UNITED STATES
NUCLEAR REGULATORY COMMISSION
WASHINGTON, D. C. 20555

Docket No. 50-213

RE: ENVIRONMENTAL QUALIFICATION OF ELECTRICAL EQUIPMENT

FIGURE 1

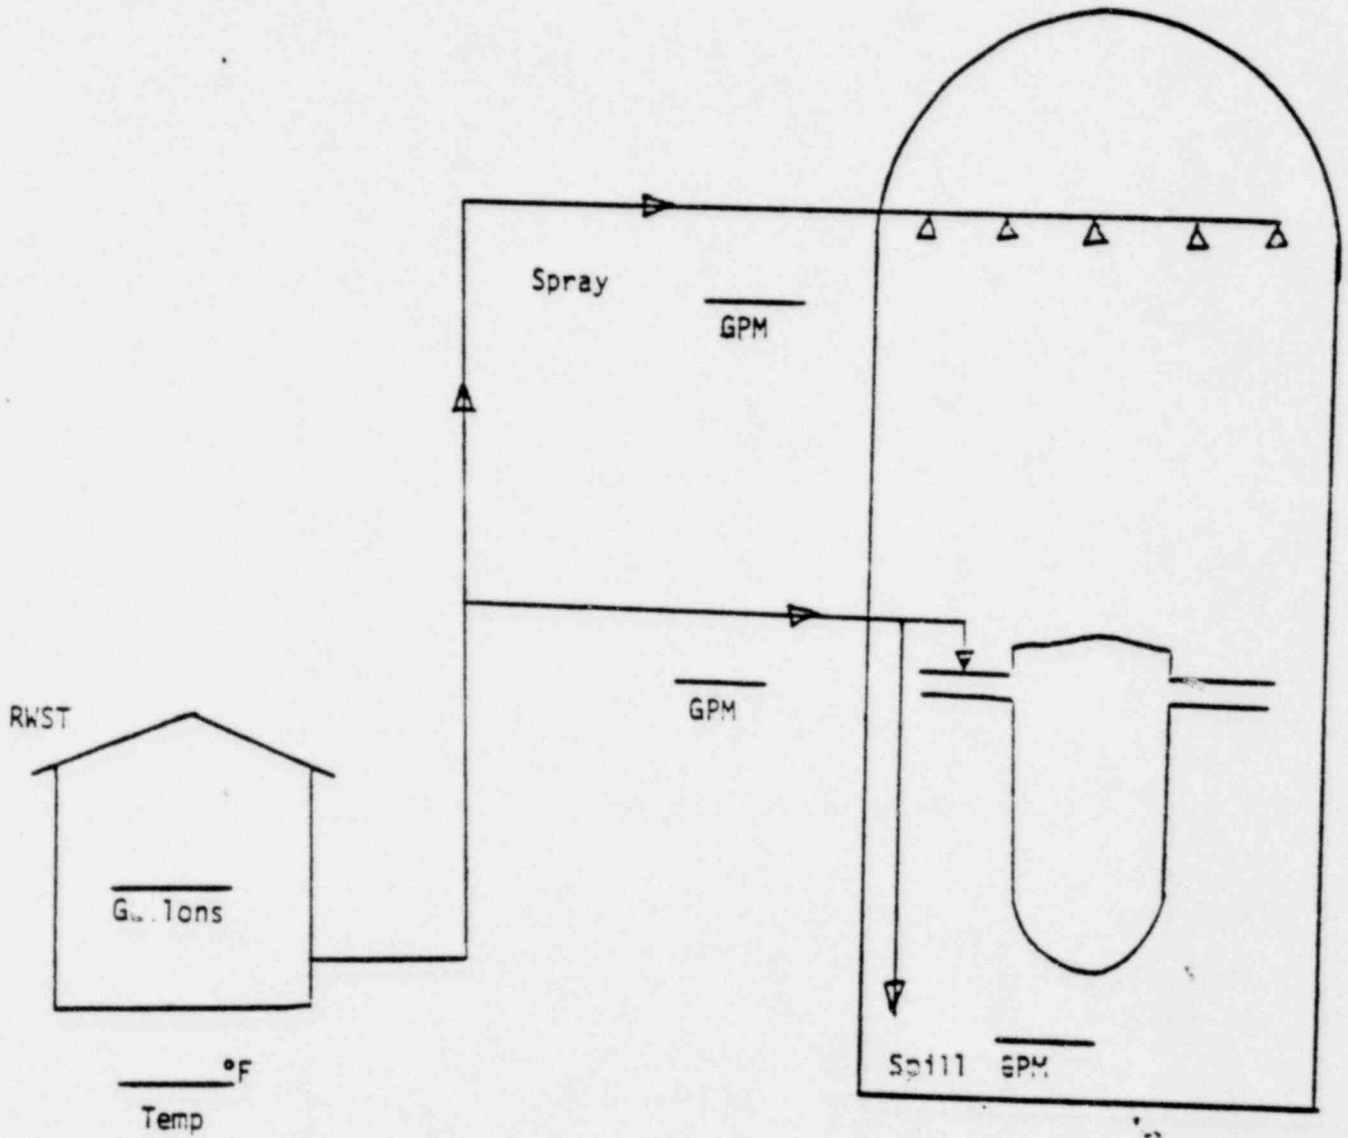
II. Figure 1 and 2 represent typical ECCS and spray systems relied on to mitigate the consequences of a pipe break. Provide the information indicated in the figures; if the plant specific systems differ from the attached figures, revise the drawings to represent your facility and provide the appropriate information.

When providing system parameters, indicate whether the values given assume a single failure and specify the single failure assumption.

FIGURE 1 - INJECTION PHASE

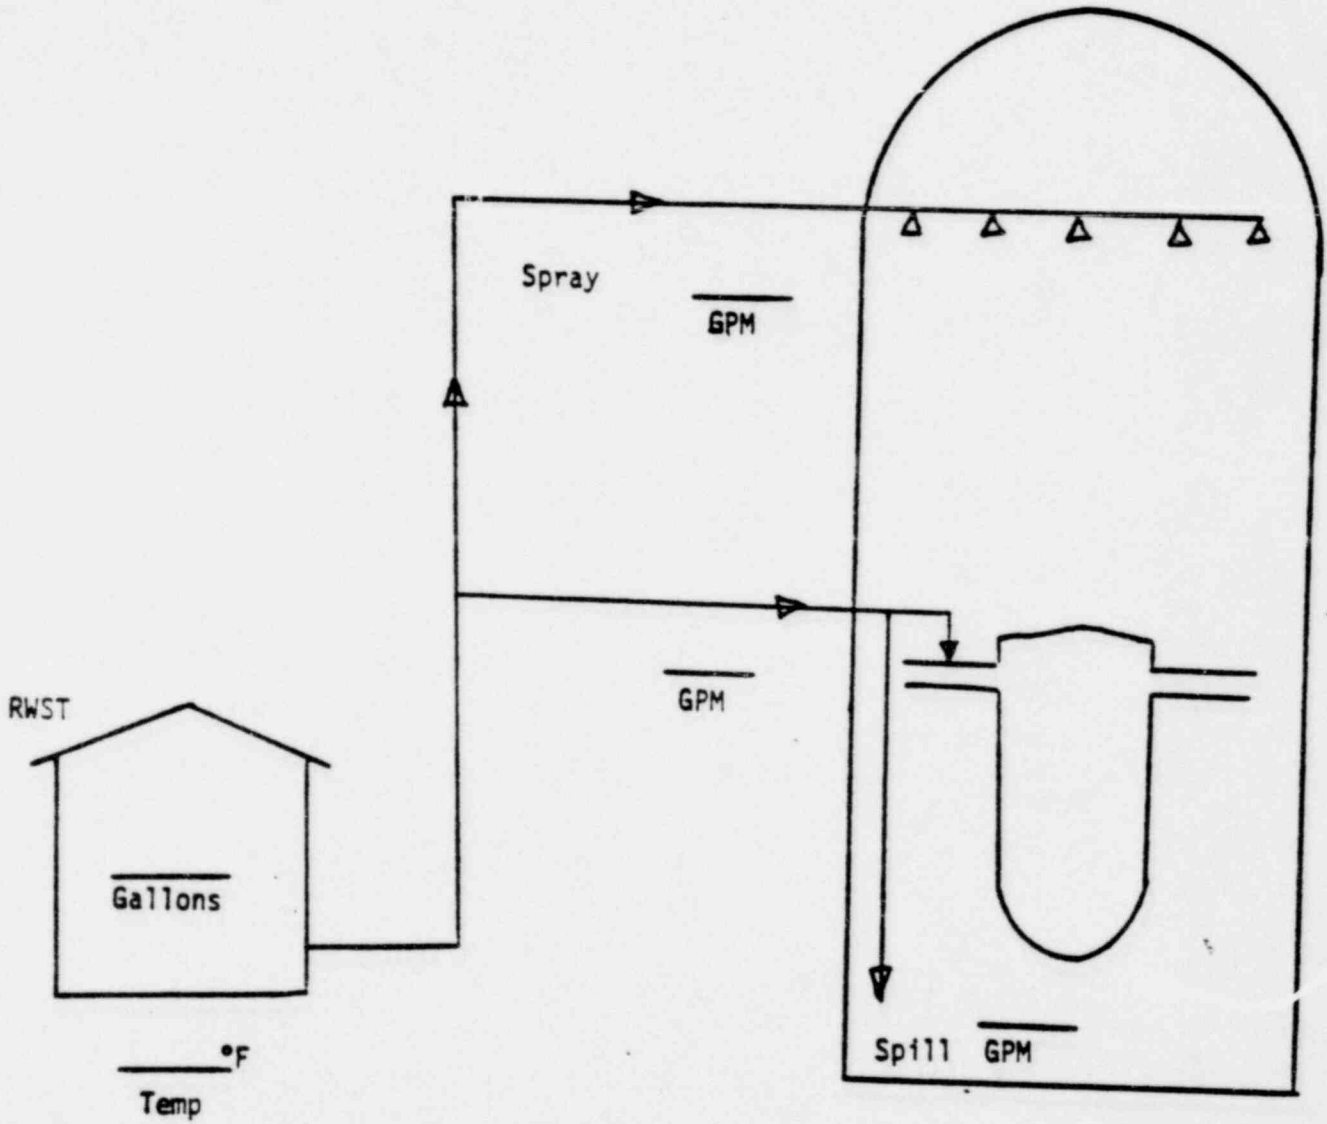
When providing system parameters, indicate whether the values given assume a single failure and specify the single failure assumption.

Figures 1 and 2 represent typical ECCS and spray systems relied on to mitigate the consequences of a pipe break. Provide the information indicated in the figures, if the plant specific systems differ from the attached figures, revise the drawings to represent your facility and provide the appropriate information.
